Fort Hamilton Pkwy, 7th Ave, Bay Ridge Pkwy Intersection Safety Improvement Alternatives

2011

DOT Proposal May 2010

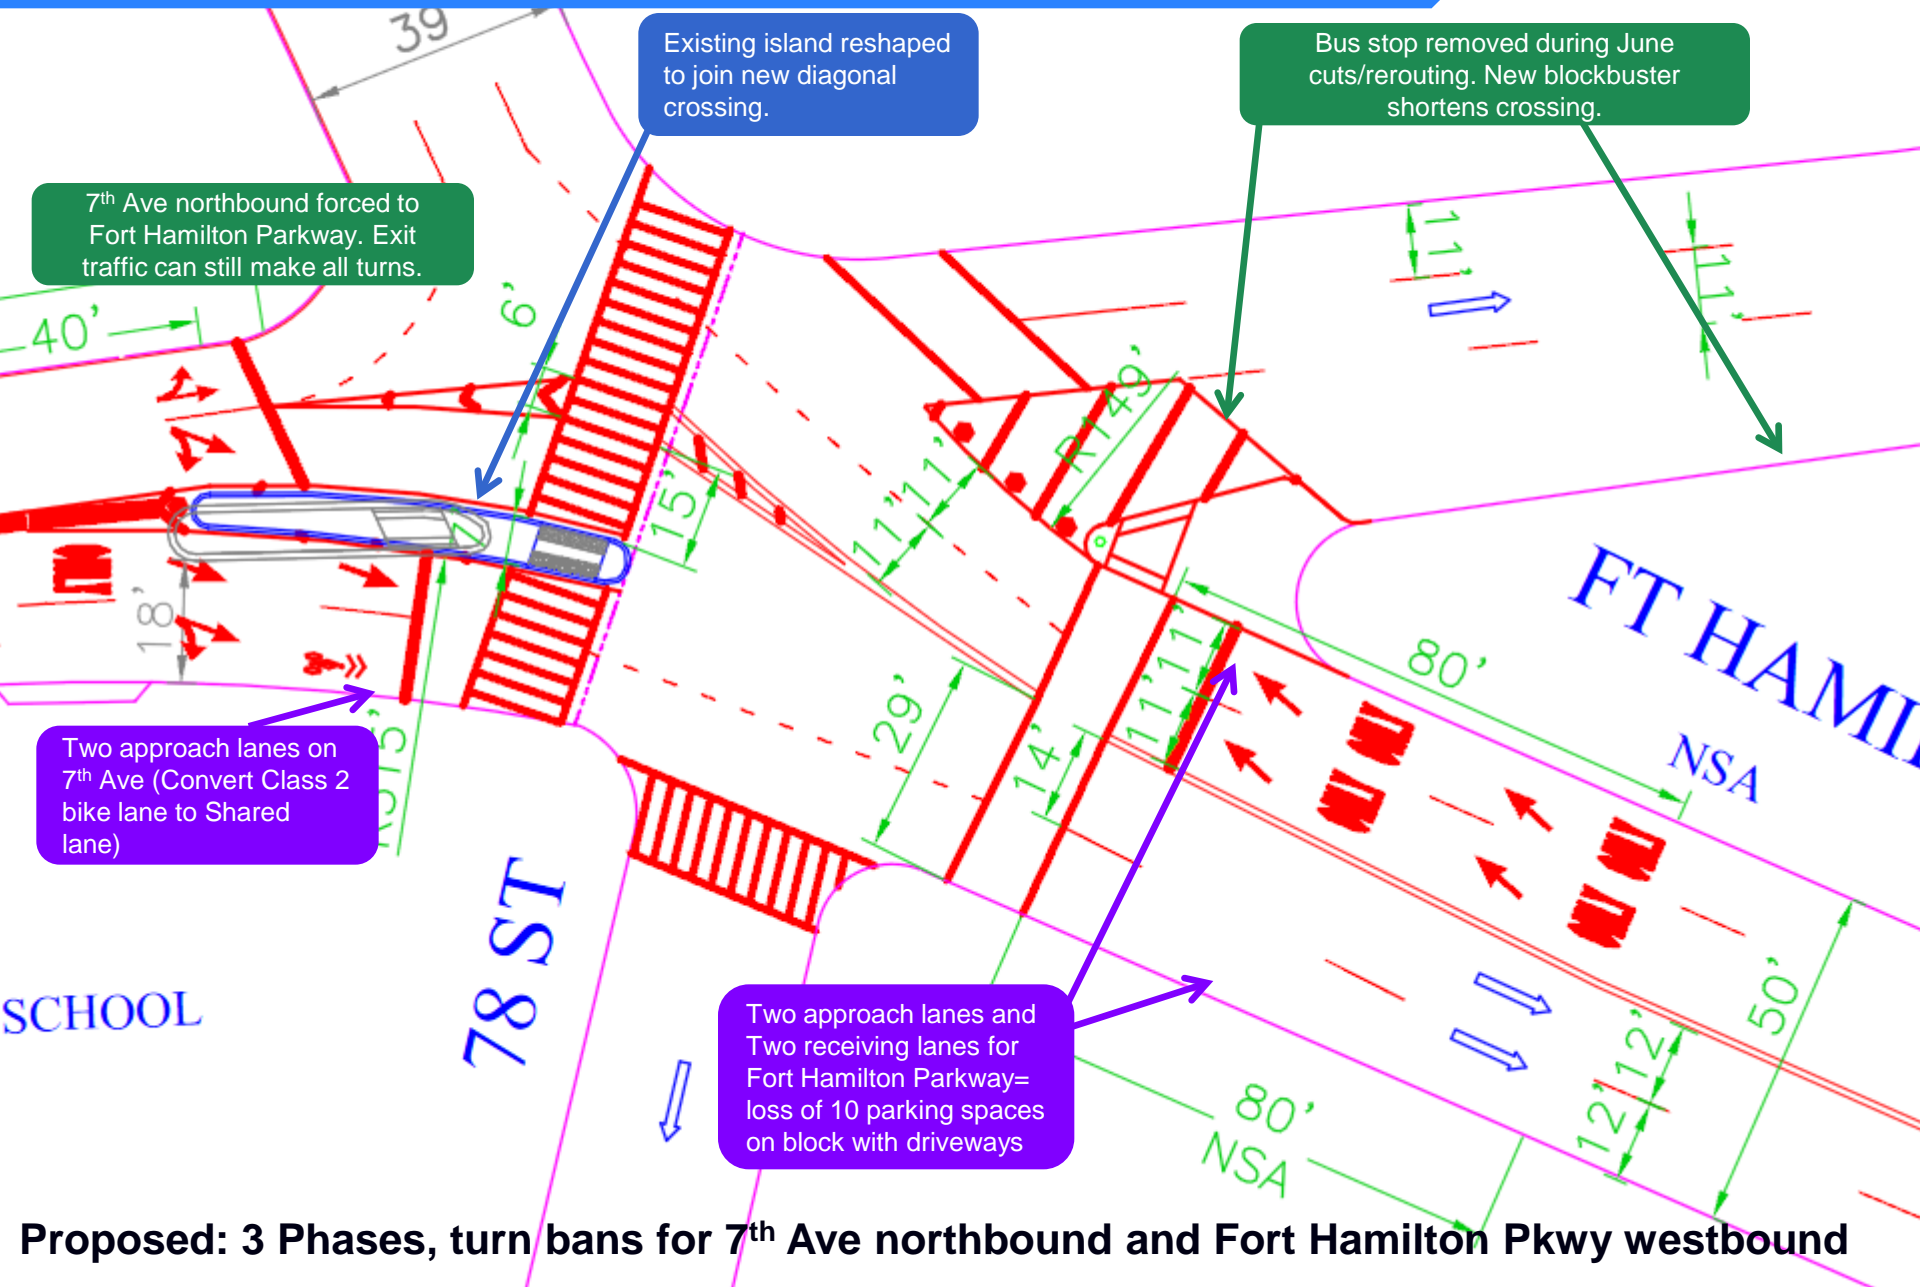
CB10 Feedback to May 25 meeting

- Establish 3-phase operation

- Establish two approach lanes for 7th Avenue local and Ft. Hamilton Pkwy westbound
- Add diagonal crosswalk between PS 127 and Ft. Hamilton Pkwy pedestrian overpass

- No truck traffic should be forced onto Ft. Hamilton Pkwy

- Direct all exiting Gowanus Expwy traffic onto 7th Avenue

- Prohibit left turns onto 78th Street from w/b Ft. Hamilton Pkwy during designated daytime hours

- Coordinate signal timing along Ft. Hamilton Pkwy between 78th St and Bay Ridge Pkwy

- Install pedestrian countdown signal

- Change the name on the Gowanus Expwy exit to read 7th Avenue instead of Ft. Hamilton Pkwy

- Ban westbound left from Bay Ridge Parkway to Fort Hamilton Pkwy southbound

- Consider reversal of 78th Street between Ft. Hamilton Pkwy and 10th Avenue.

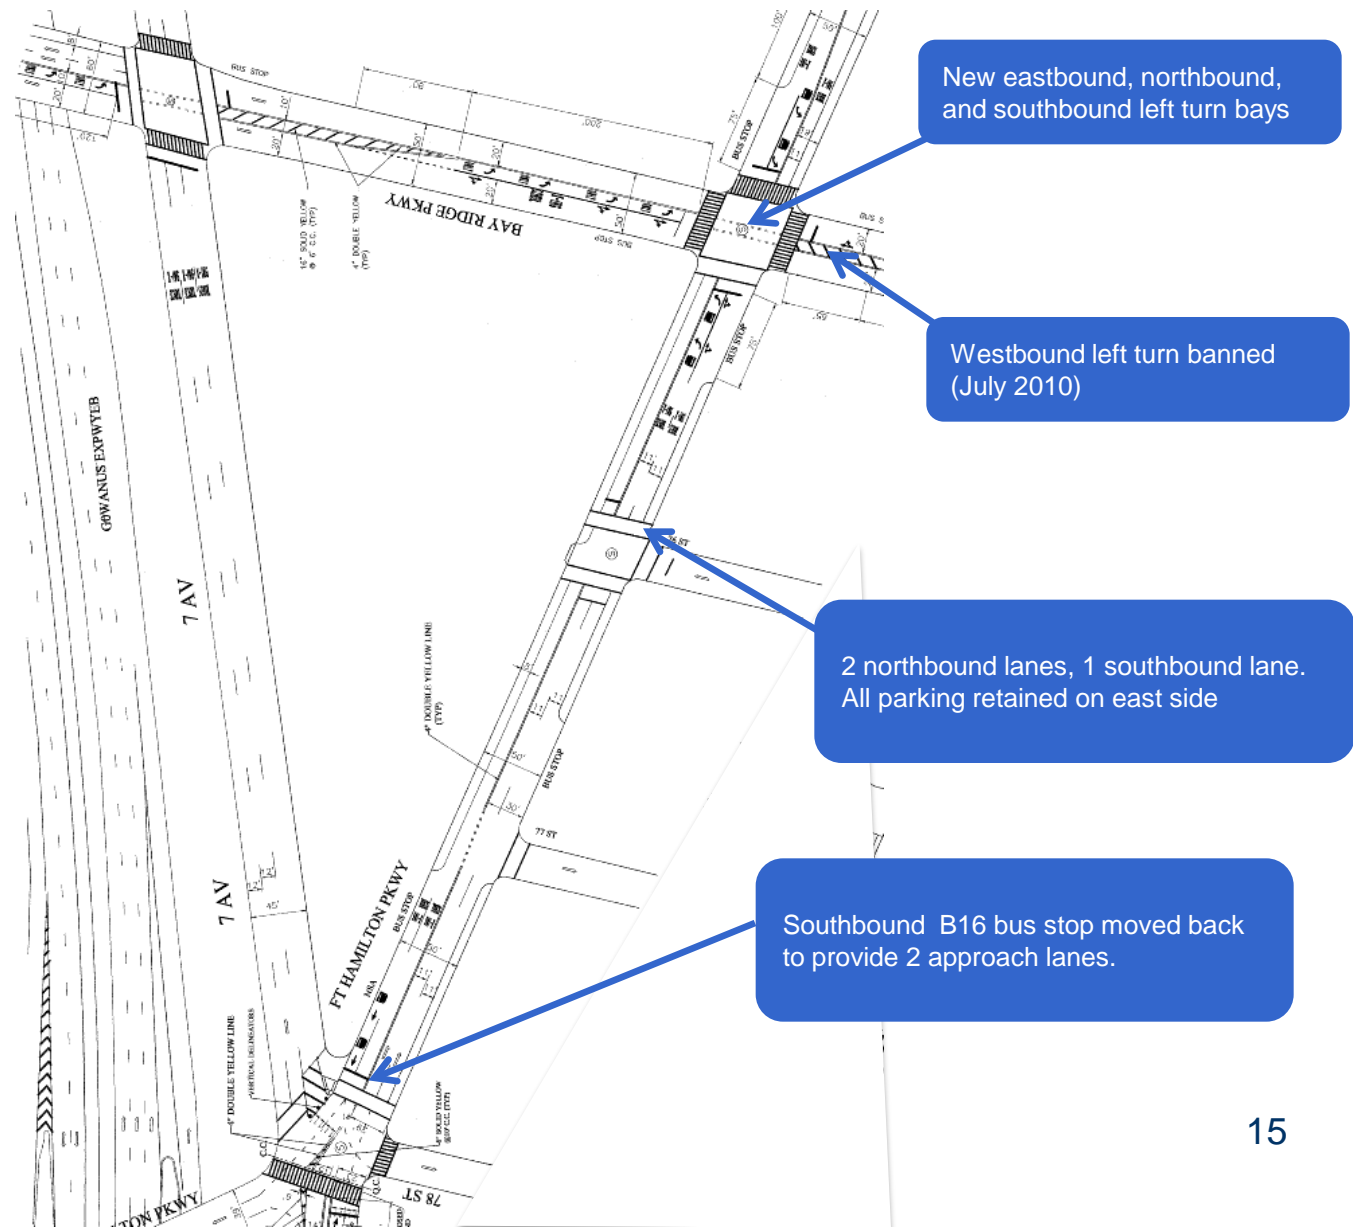
• Change the name on the Gowanus Expwy exit to read 7th Avenue instead of Ft. Hamilton Pkwy

1. Unintended Consequences: 7th Avenue is a truck route: label could attract an increase in trucks
2. Unlikely that truck drivers choose their movements at the intersection after the ramp
3. Potential to confuse car drivers looking for the Fort Hamilton Parkway exit
4. Existing “No Trucks over 33 Feet” sign already keeps most of the largest trucks off this ramp
